TWIN CHIMNEYS

VILLAGE F

PLAT THREE

STORM & SANITARY SEWER MEASUREMENTS

1/13

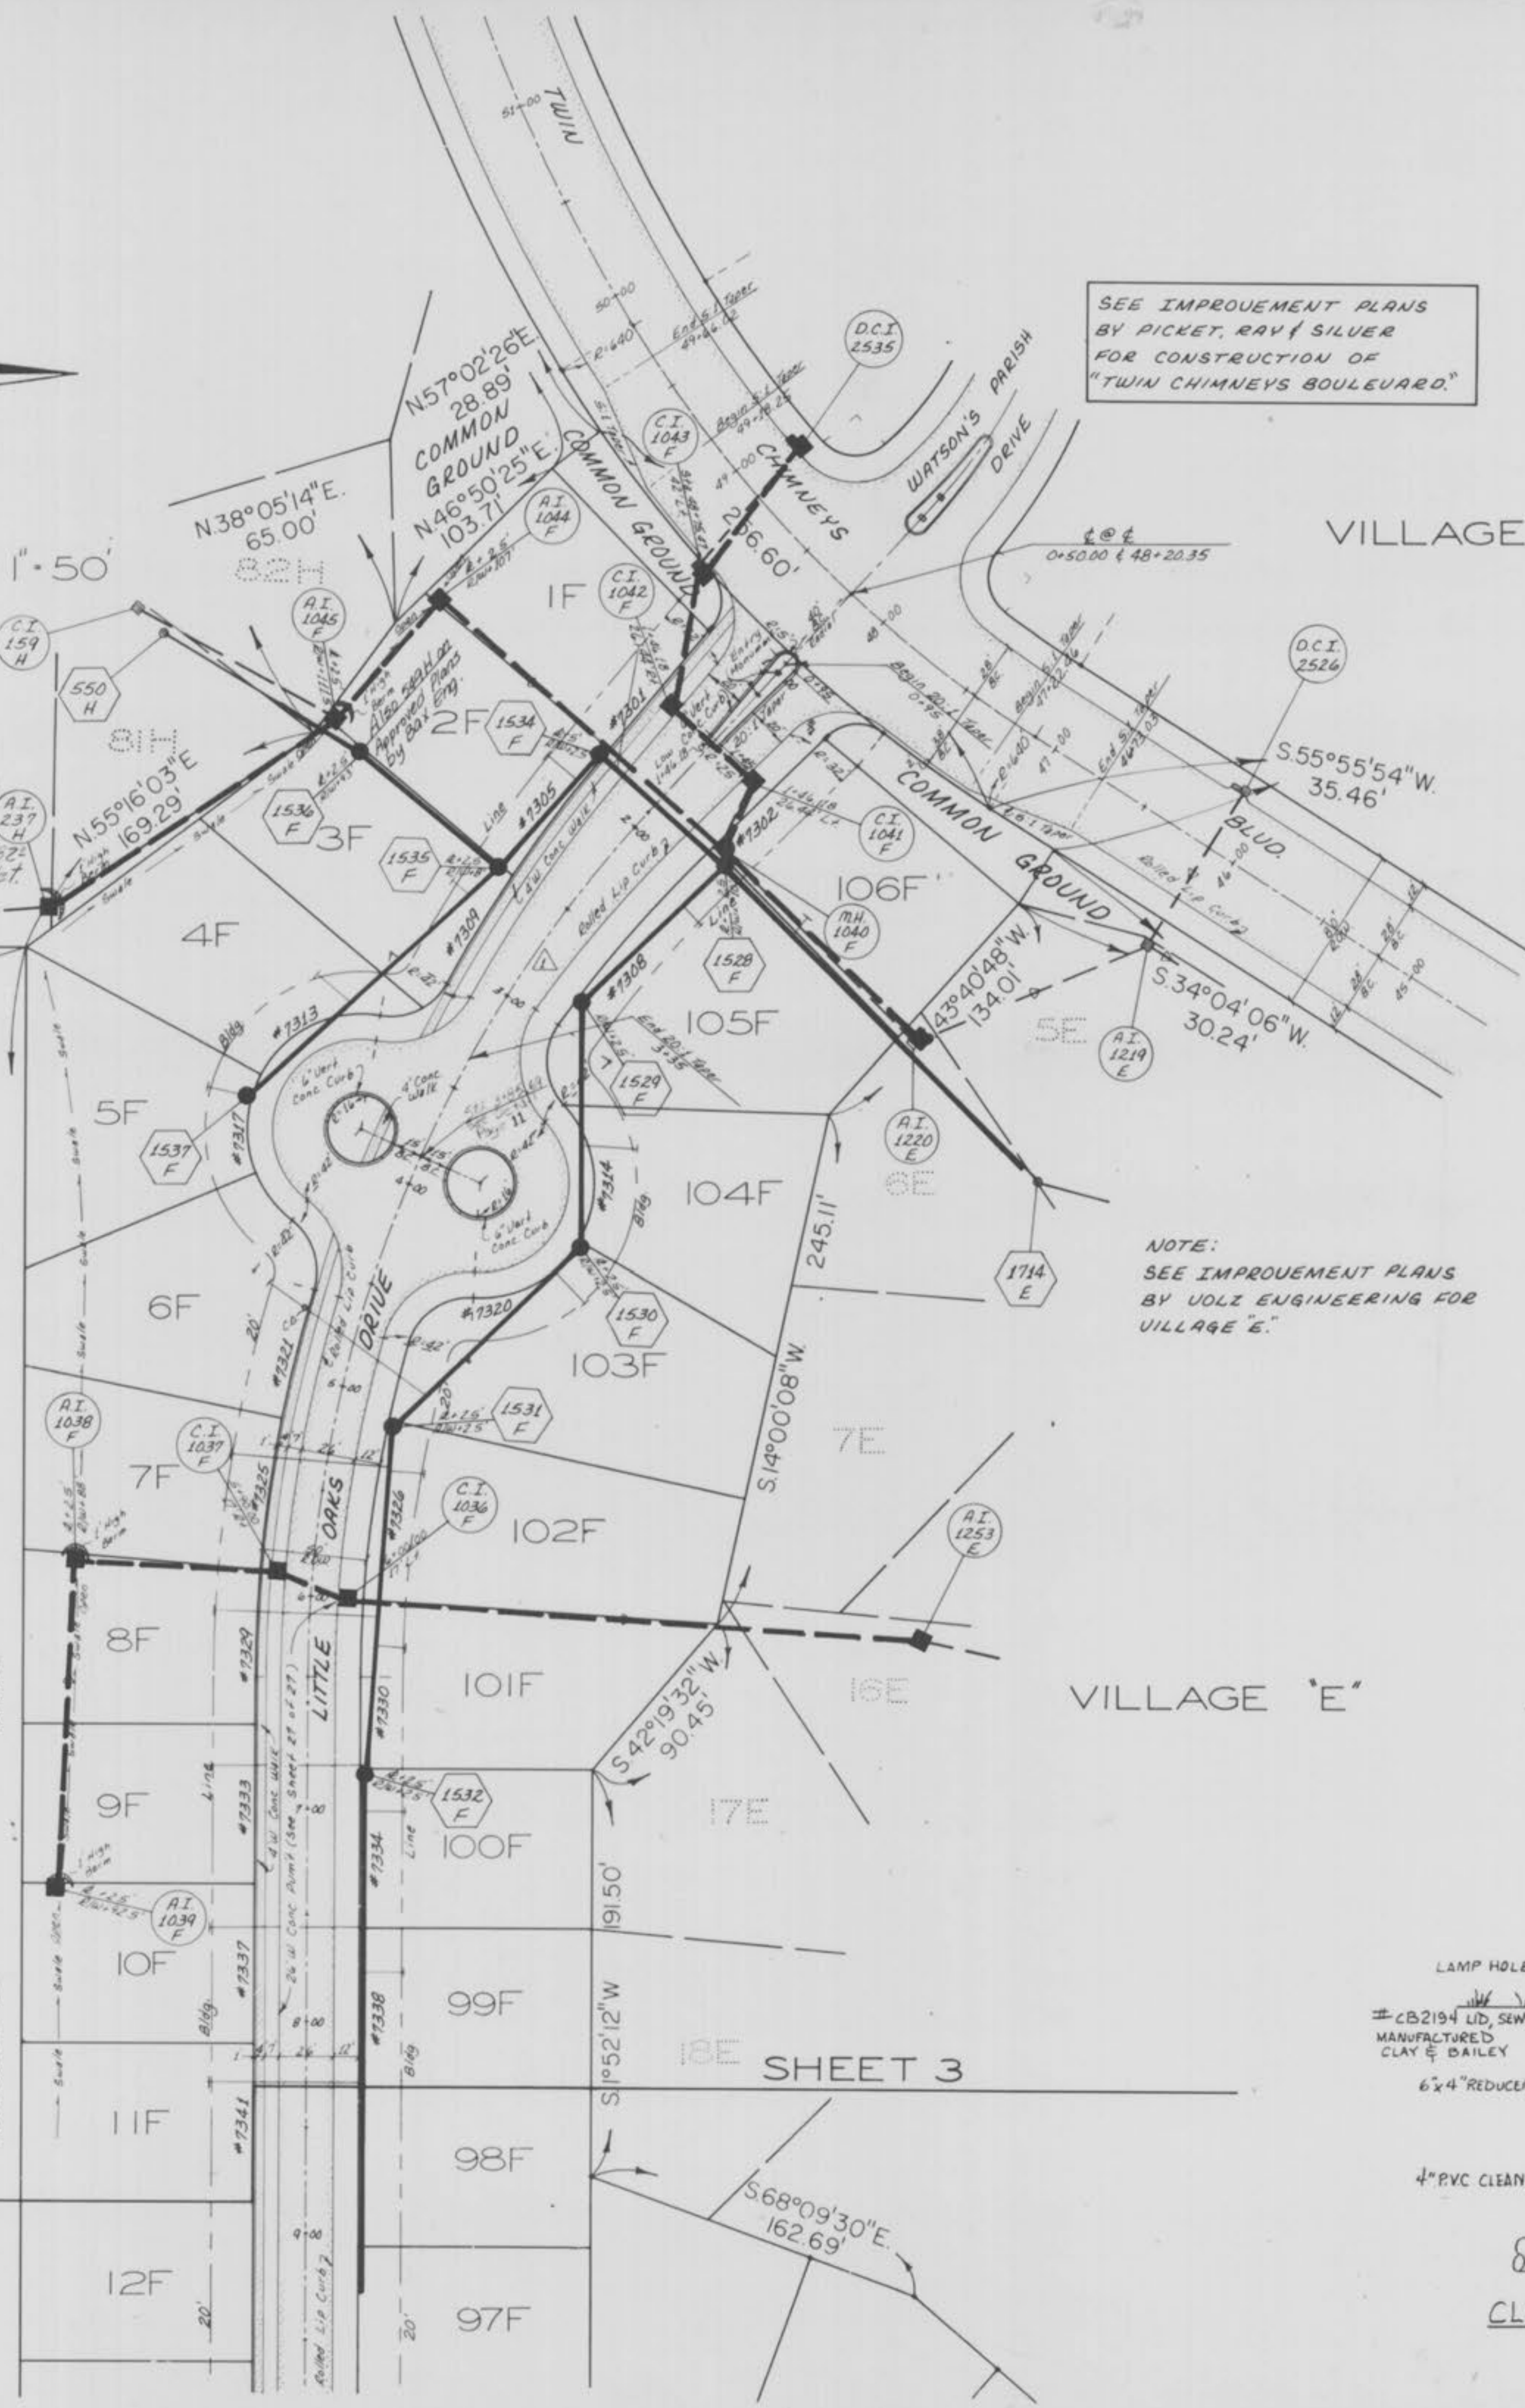
We have measured the existing sewer lengths sizes, flowlines, depths of structures and the results of these measurements are shown on this plan by lining out the planned number and indicating the measured number adjacent to the planned number. All other numbers have not been measured or verified.

3/13

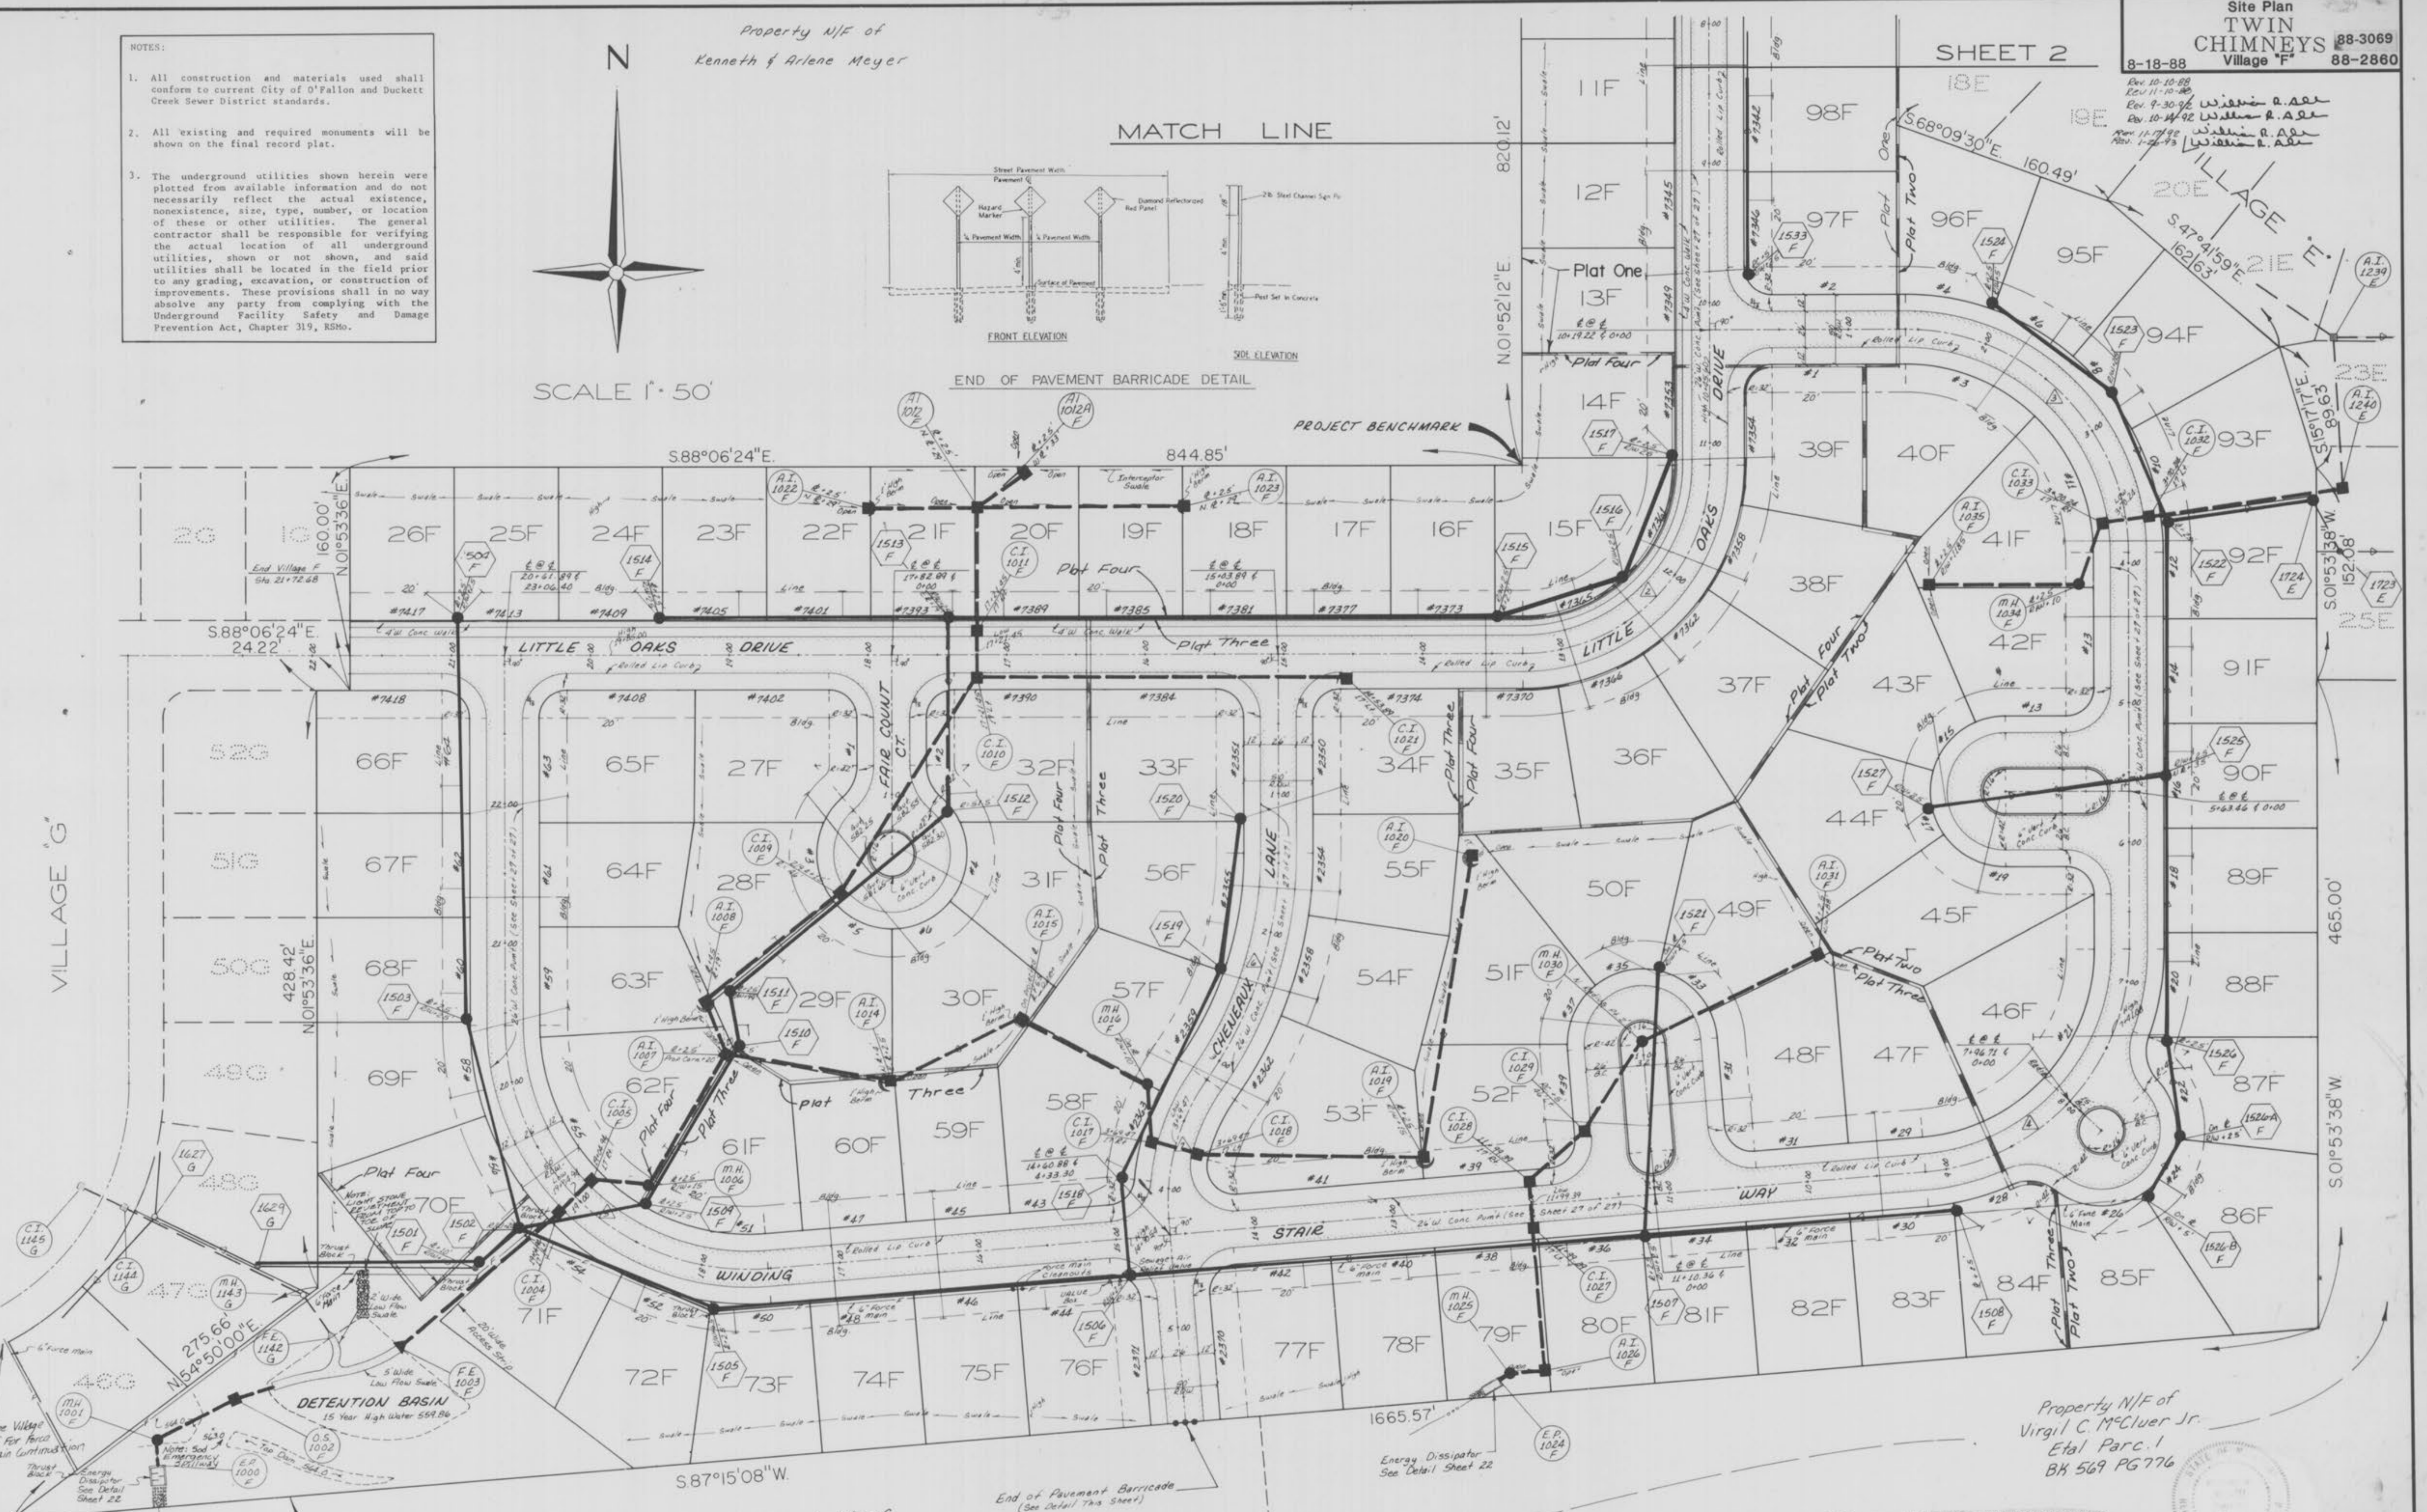
We have measured the existing sewer lengths sizes, flowlines, depths of structures and the results of these measurements are shown on this plan by lining out the planned number and indicating the measured number adjacent to the planned number. All other numbers have not been measured or verified.
